Subdivision Authority

File No. LDA08-0308

RE: Tentative plan of subdivision to create 82 single detached residential lots, 76 semi-detached residential lots, three (3) medium density residential lots, one (1) public utility lot from portions of SW 14-51-25-4, SE 14-51-25-4, and Lot 1, Plan 962 1479, located west of 141 Street SW and north of 41 Avenue SW; **CHAPPELLE**

I The Subdivision by Plan is APPROVED on July 29, 2010 subject to the following conditions:

SUBDIVISION CONDITIONS OF APPROVAL MAP

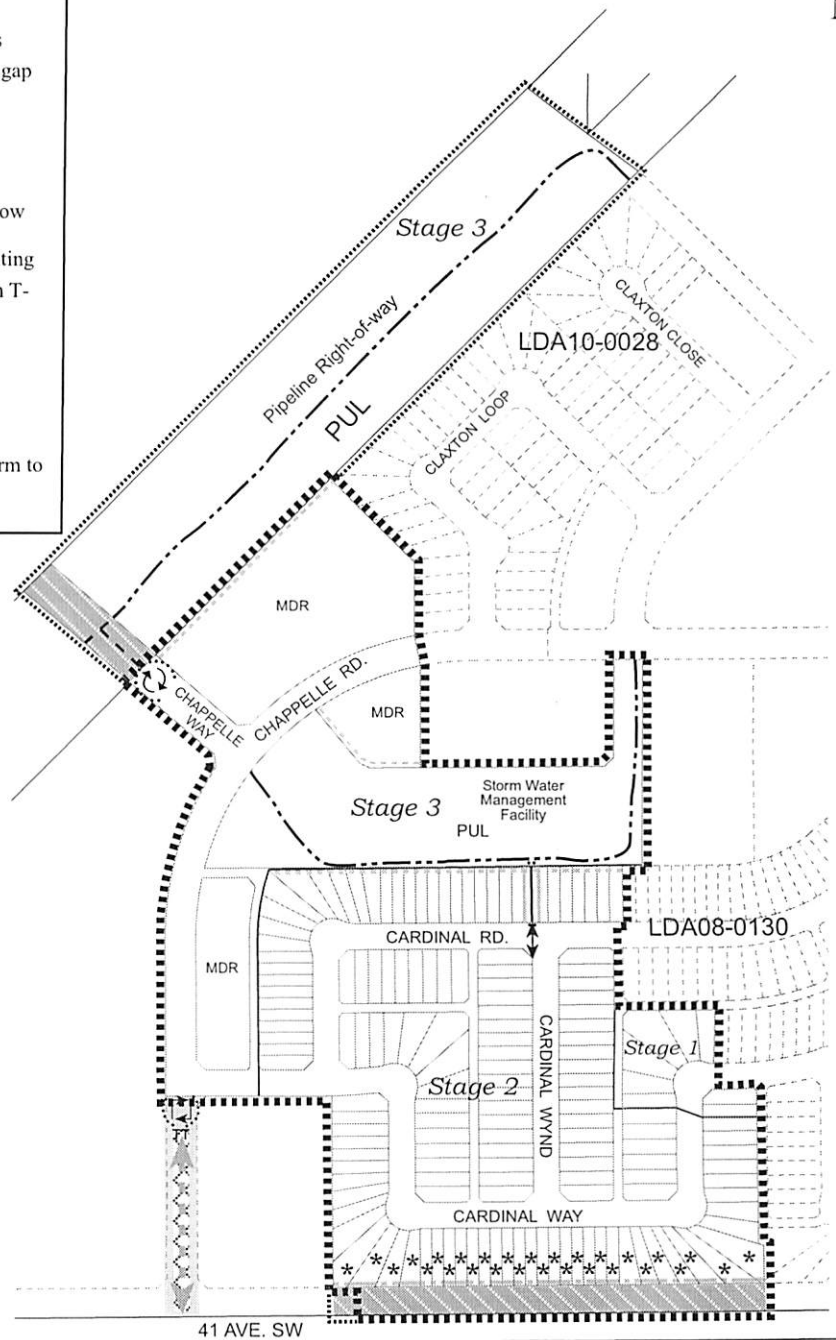
5. that the subdivision boundary be amended to include the dedication of a PUL for a portion of pipeline right-of-way, and the dedication of a portion of Chappelle Way and a portion of 41 Avenue SW to the satisfaction of the Transportation Department, as shown on the "Conditions of Approval" map, Enclosure I;

6. that the dedication of 41 Avenue SW and Chappelle Way conform to an approved concept plan, or be to the satisfaction of the Transportation Department, as shown on the "Conditions of Approval" map, Enclosure I;

8. that the owner prepare a restrictive covenant in favour of the City of Edmonton that will be registered against the proposed lots backing on the noise attenuation wall as shown on the "Conditions of Approval" map, Enclosure I, to protect the integrity of the noise attenuation facility (berm and no gap fence); that the owner provide an emergency access easement to facilitate access via the temporary emergency access to 41 Avenue SW, as shown on the "Conditions of Approval" map, Enclosure I; and
9. that the owner pay all outstanding property taxes prior to the endorsement of the plan of subdivision.

8. that the owner construct temporary turnarounds to the satisfaction of the Transportation Department, as shown on the "Conditions of Approval" map, Enclosure I;

9. that the owner construct a 1.5 m concrete sidewalk with bollards and lighting, as shown on the "Conditions of Approval" map, Enclosure I;
10. that the walkway must align with the intersecting curb ramp across the intersection and the owner register the walkway as legal road rights-of-way, as shown on the "Conditions of Approval" map, Enclosure I;

11. that the engineering drawings include the construction of a temporary 4 m wide gravel emergency access with T-bollards, as shown on the "Conditions of Approval" map, Enclosure I;

12. that the owner construct a 3 m asphalt multi-use trail with a dividing yellow centerline and "Shared Use" signage, as shown on the "Conditions of Approval" map, Enclosure I;

13. that the owner construct a 3 m temporary asphalt multi-use trail within Chappelle Way right-of-way, until such time as the future Chappelle Way is constructed, as shown on the "Conditions of Approval" map, Enclosure I;

14. that the owner construct the berm centred on the property and fences positioned wholly on privately owned lands as shown on the "Conditions of Approval" map, Enclosure I;
15. that the owner construct lighting, multi-use trails, sidewalks, and temporary turnarounds, to the satisfaction of the Transportation and Asset Management and Public Works Departments in the locations identified on the "Conditions of Approval Map", Enclosure I; and
16. that the owner is responsible for the design, landscaping and construction within the public utility lots, utility rights-of-way, road islands, boulevards, medians, walkways, and Municipal Reserve parcels, to the satisfaction of the Transportation and Asset Management and Public Works Departments.
